Development Review Division

SUBJECT: SUB20-002, Douglas 234 Filing 6 – Minor Development Plat Review Comments v2

A REPLAT OF LOT 1, BLOCK 10, DOUGLAS 234 FILING NO. 1, BEING LOCATED IN SOUTHEAST QUARTER OF SECTION 29, TOWNSHIP 6 SOUTH, RANGE 66 WEST 6TH P.M. TOWN OF PARKER, COUNTY OF DOUGLAS, STATE OF COLORADO SHEET 1 OF 2

LANDSCAPE AND IRRIGATION PLANS
DOUGLAS COUNTY 234
FILING NO. 6
DOUGLAS COUNTY, COLORADO

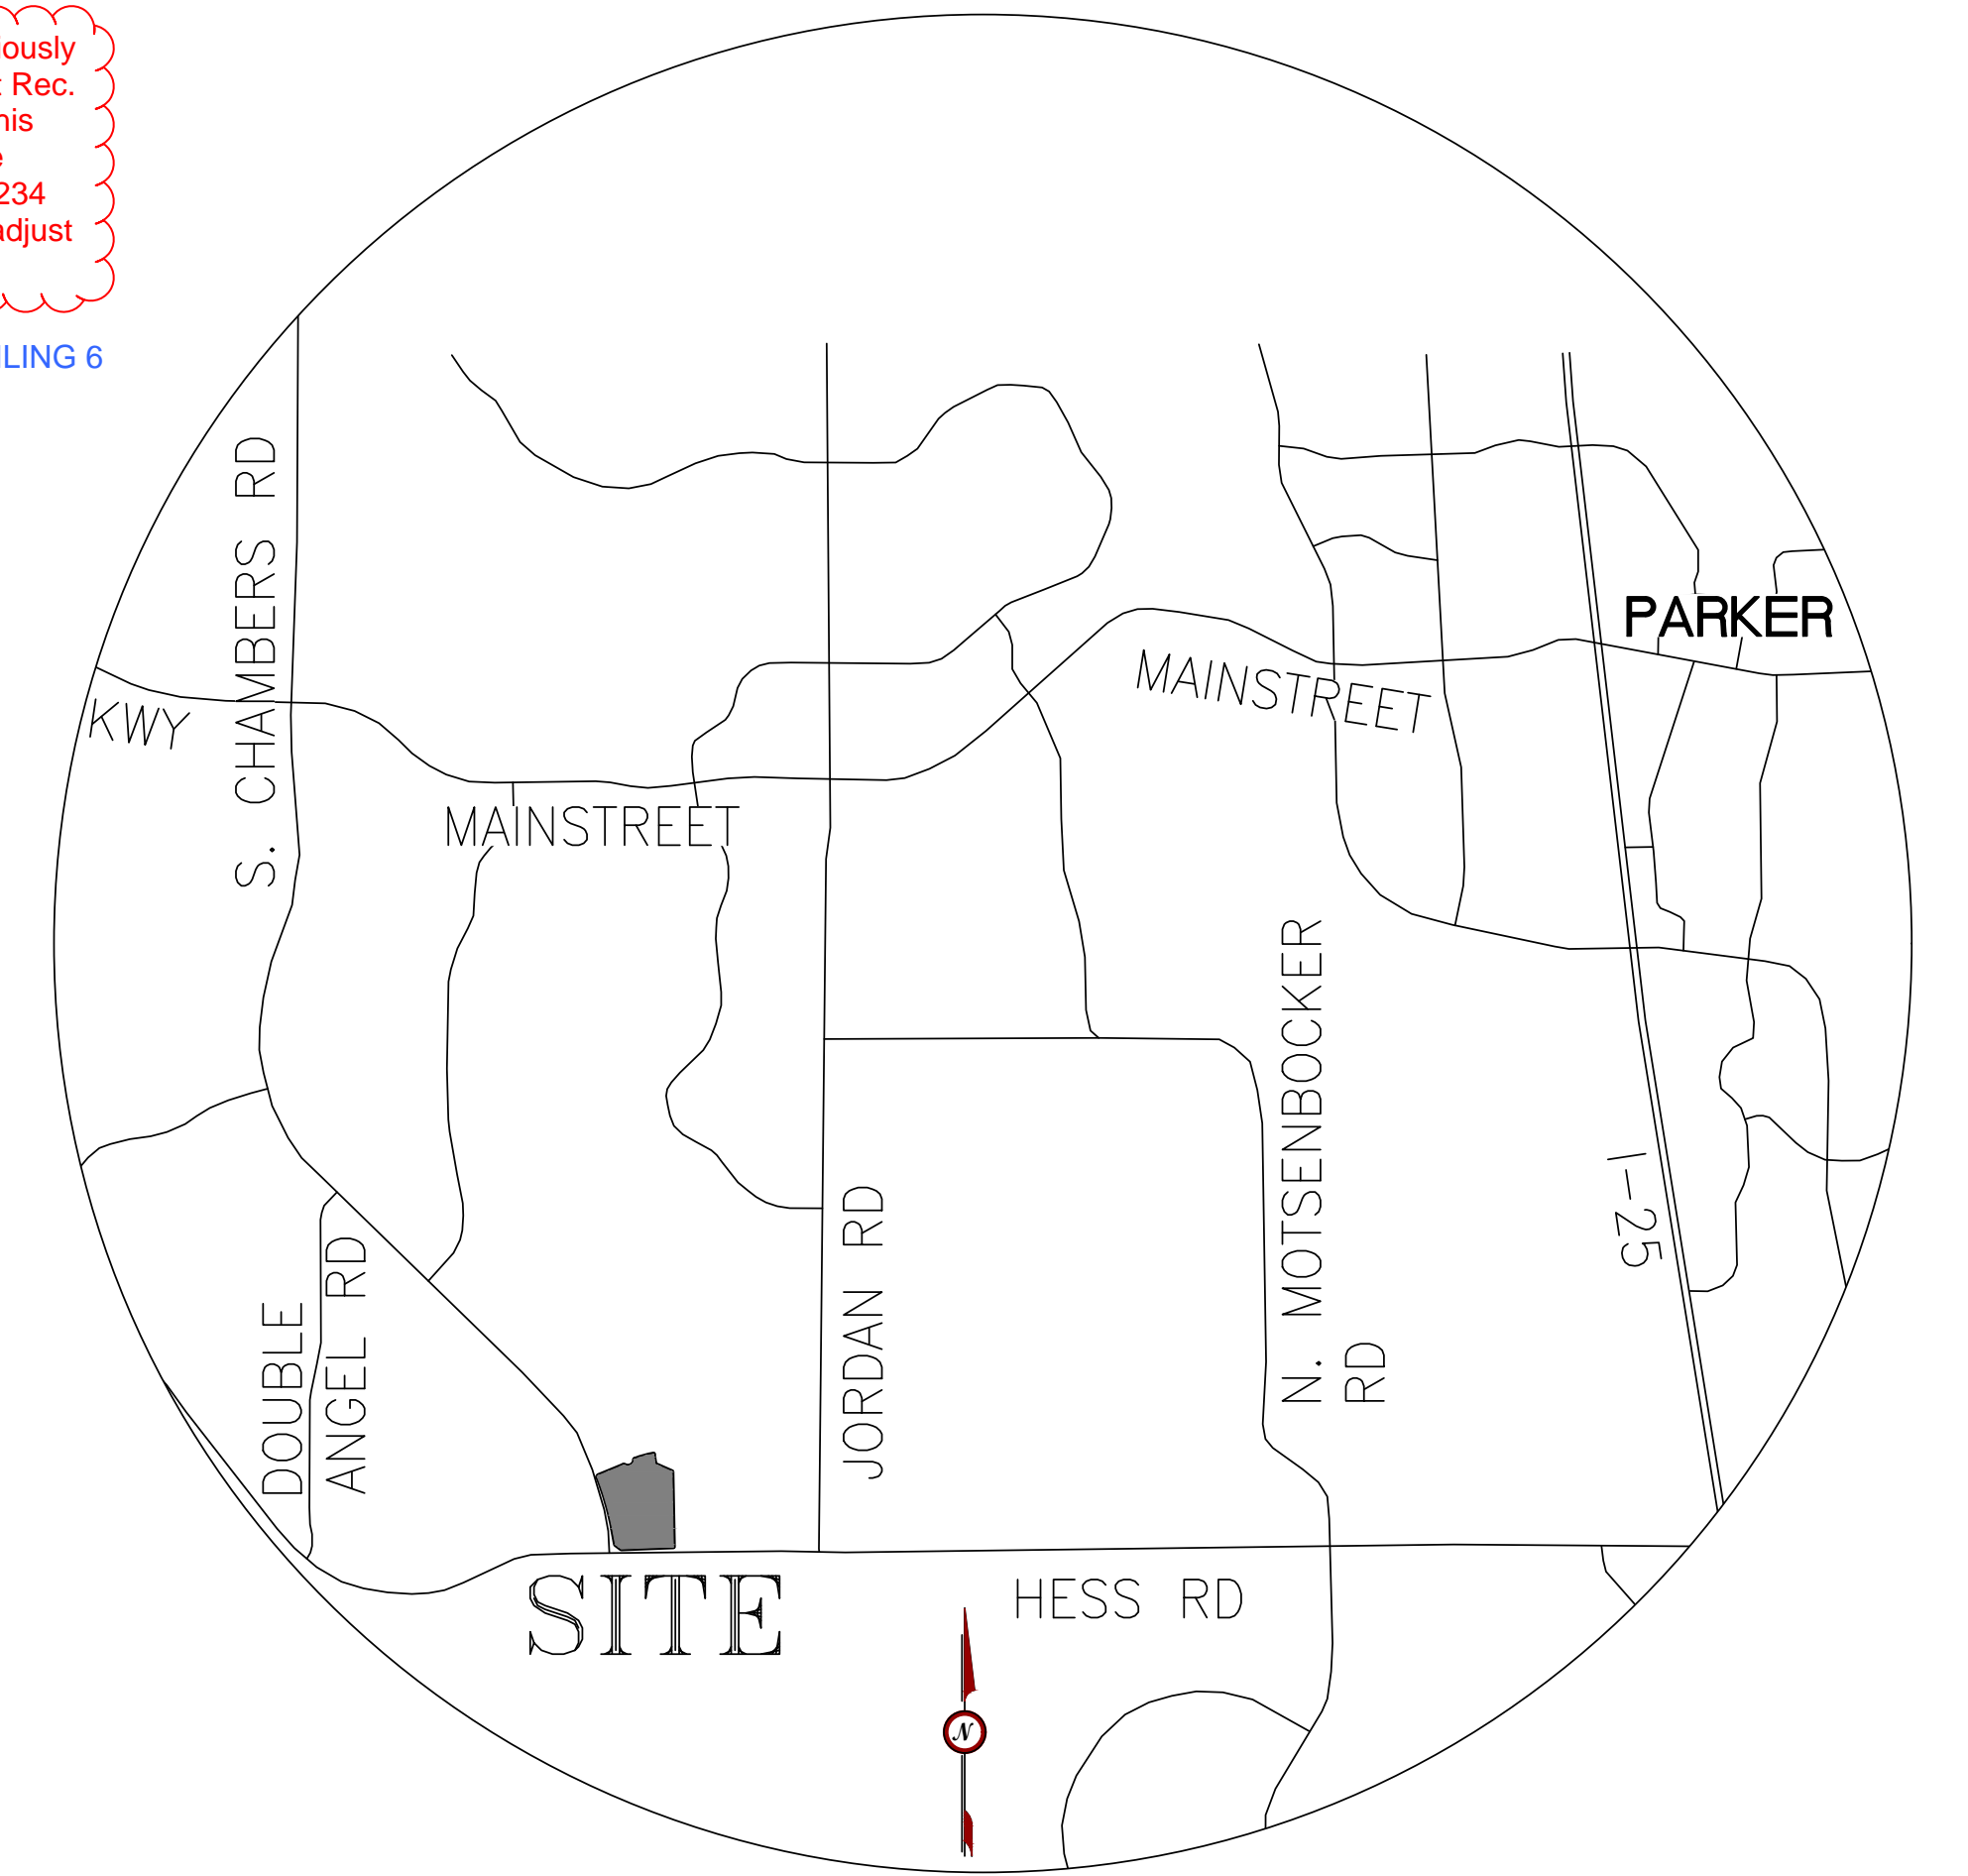
Filing 5 has previously been recorded at Rec. #2004038425. This project should be named Douglas 234 Filing 6. Please adjust accordingly.

Please add the following:
- Title Verification
- Deed of Trust (if applicable)

Please add a Land Use Summary Table showing all lots and tracts with the following information:
- Area (SF)
- Area (AC)
- Land Usage (i.e., future development, right-of-way, utility drainage, etc.)
- Ownership/Maintenance

UPDATED TO FILING 6

ADDED TITLE VERIFICATION

ADDED SUMMARY TABLE

SHEET 2 OF 2

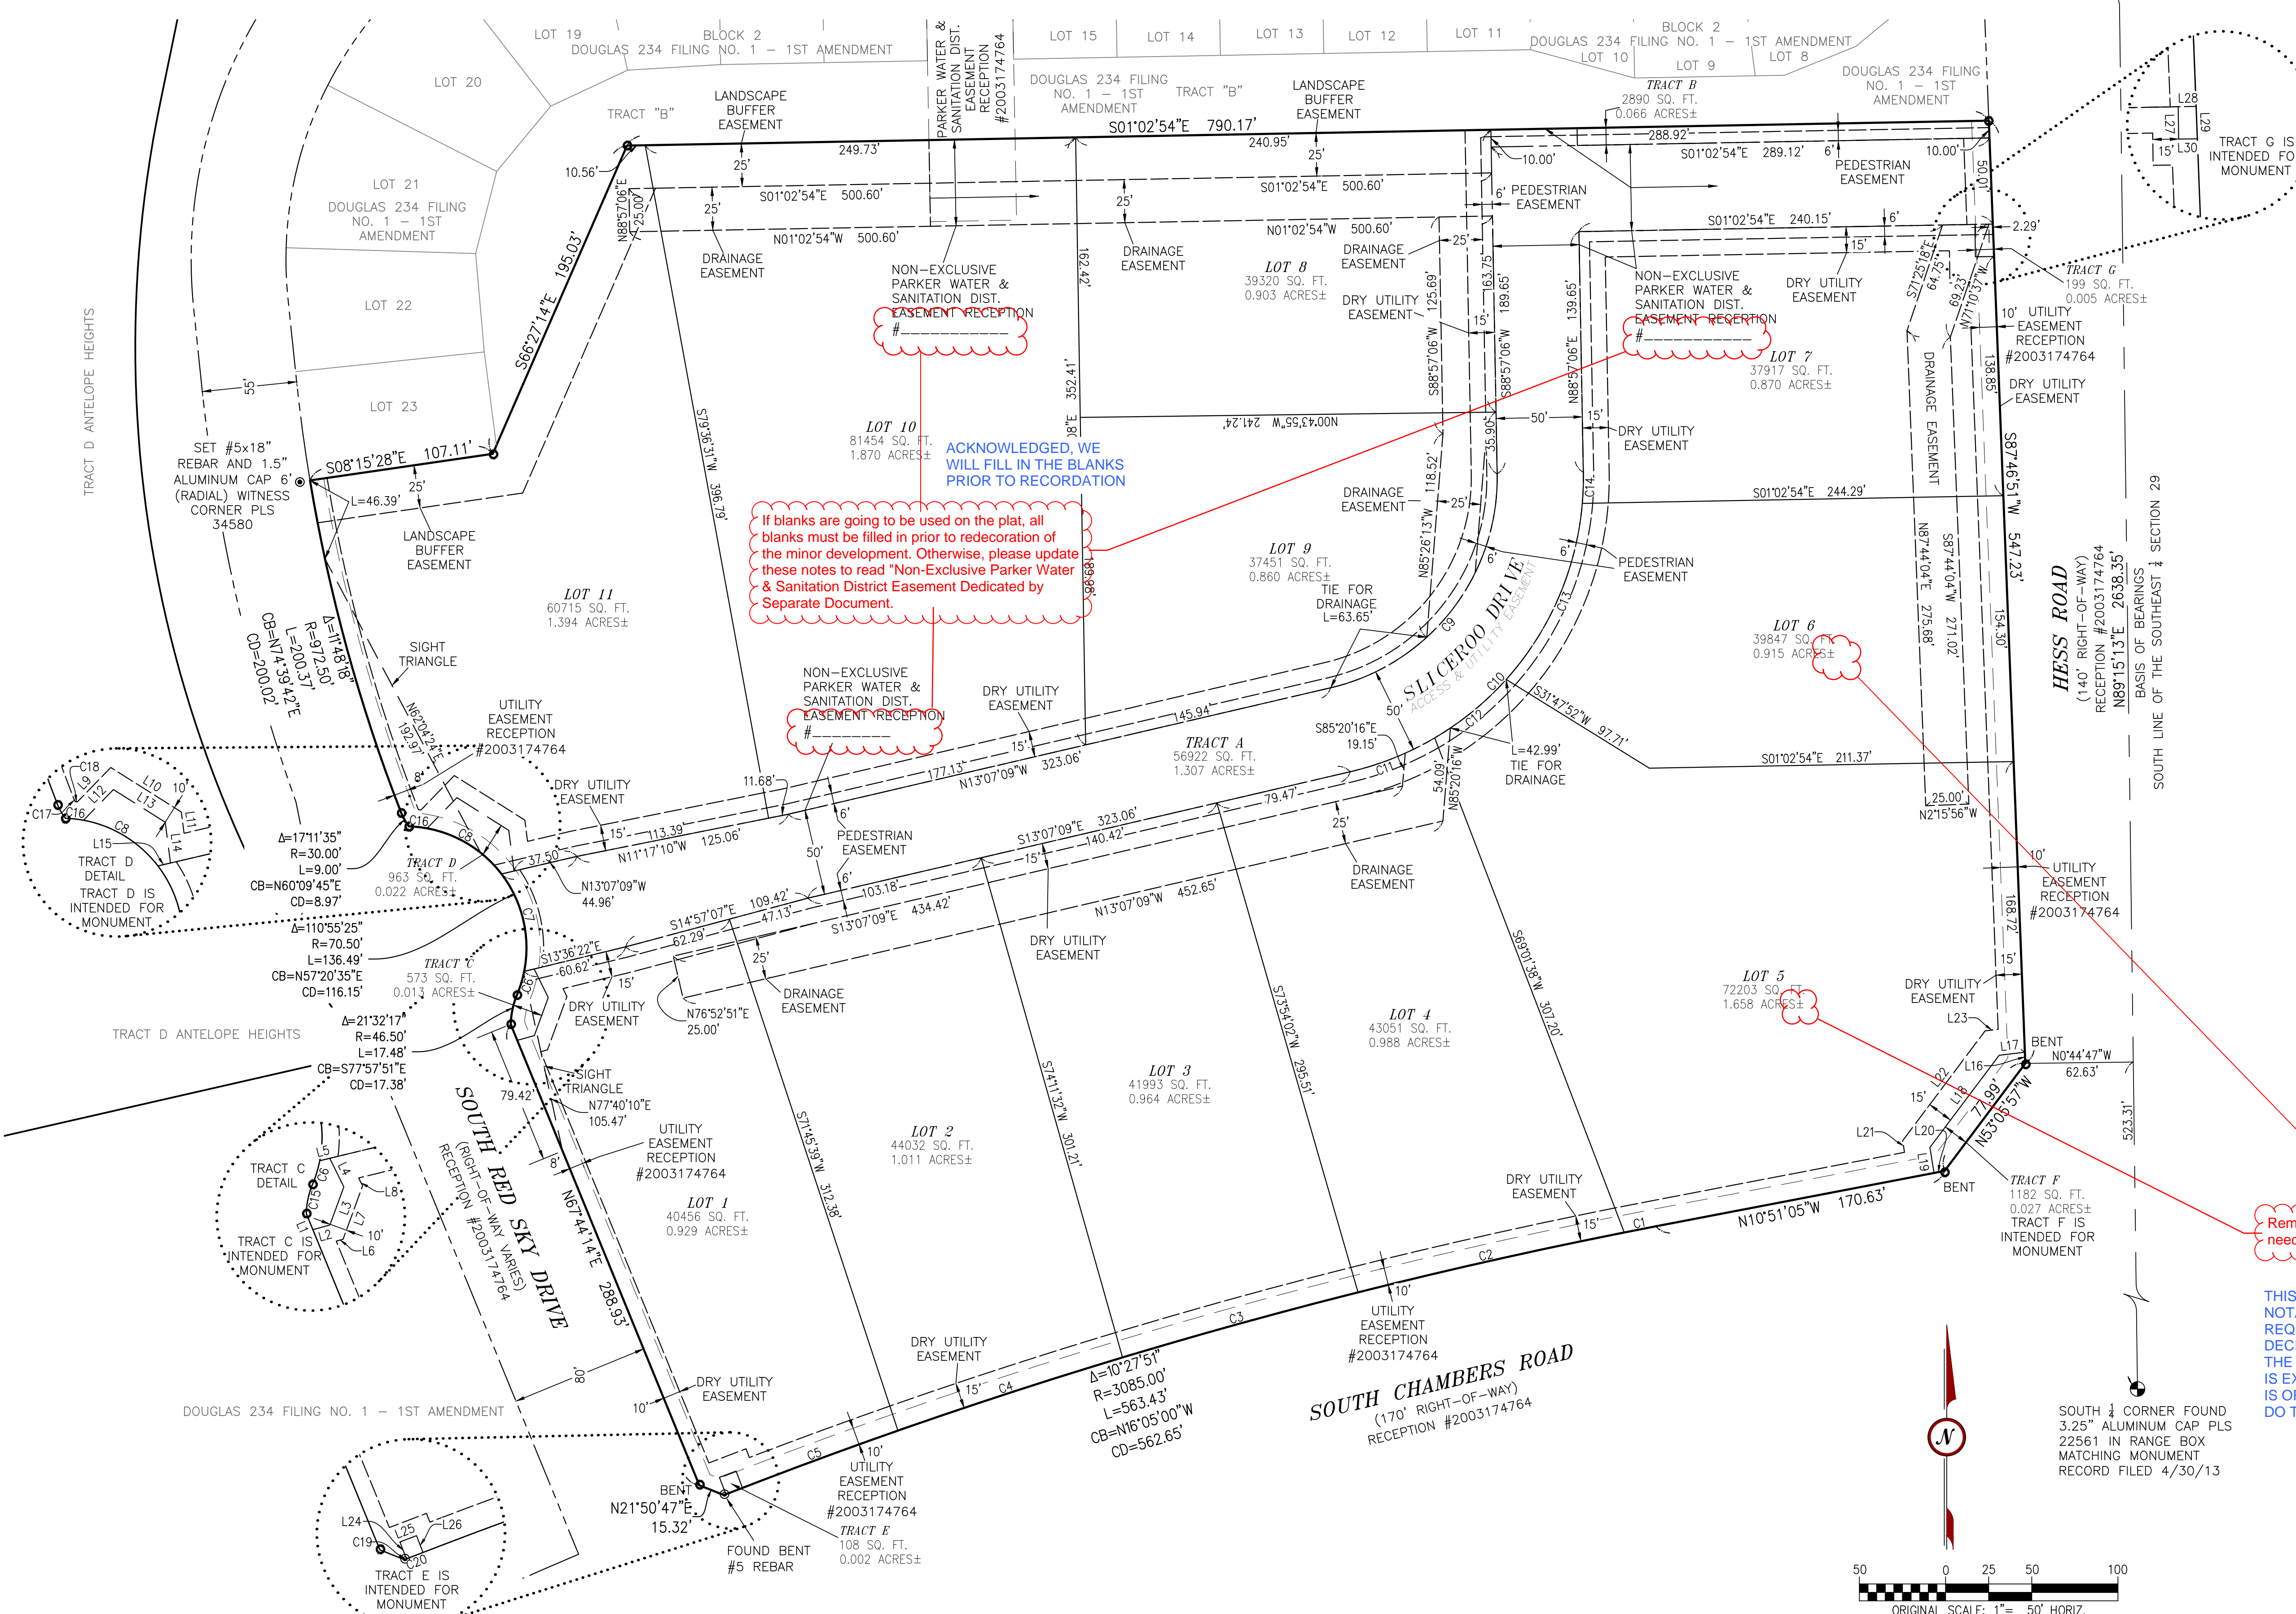
Filing 5 has previously been recorded at Rec. #2004038425. This project should be named Douglas 234 Filing 6. Please adjust accordingly.

If blanks are going to be used on the plat, all blanks must be filled in prior to recordation of the minor development. Otherwise, please update these notes to read "Non-Exclusive Parker Water & Sanitation District Easement Dedicated by Separate Document."

Remove all +/- Exact values need to be provided.

UPDATED TO FILING 6

ACKNOWLEDGED, WE WILL FILL IN THE BLANKS PRIOR TO RECORDATION

THIS IS STANDARD PLAT NOTATION, IT WOULD REQUIRE SIGNIFICANT DECIMALS TO BE EXACT. THE SQUARE FOOTAGE IS EXACT, THE ACREAGE IS OFF BY 43 FT IF YOU DO THE MATH
